NO: REL - 208 PRODUCT: G3VM-61G1 MOSFET Relay

DATE: May 2018 TYPE: DISCONTINUATION - Streamline Product Offering

# **G3VM-61G1 MOSFET Relay - DISCONTINUATION**

# <u>G3VM-61G1 Recommended Replacement -- Differences from discontinued product:</u>

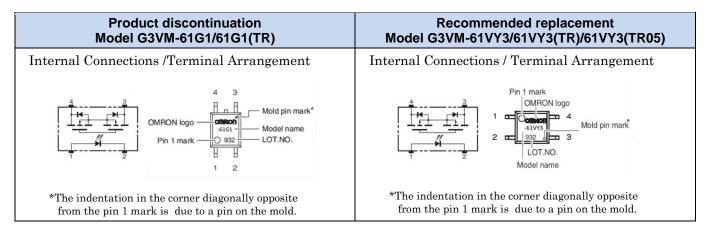
Recommended replacement Model	Body Color	Dimen -sions	Wire connection	Mounting Dimensions	Charact - eristics	Operation ratings	Operation methods
G3VM-61VY3 G3VM-61VY3(TR) G3VM-61VY3(TR05)		*	**	**	*	*	**

# **Mounting dimensions:**

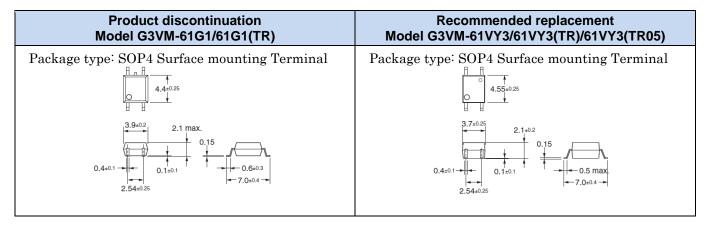
Product discontinuation Model G3VM-61G1/61G1(TR)	Recommended replacement Model G3VM-61VY3/61VY3(TR)/61VY3(TR05)					
Mounting dimensions (TOP VIEW)	Mounting dimensions (TOP VIEW)					
Tolerance ±0.1mm	Tolerance ±0.1mm					
0.8	6 to 6.3					
0.8	1.2					
2.54	0.8
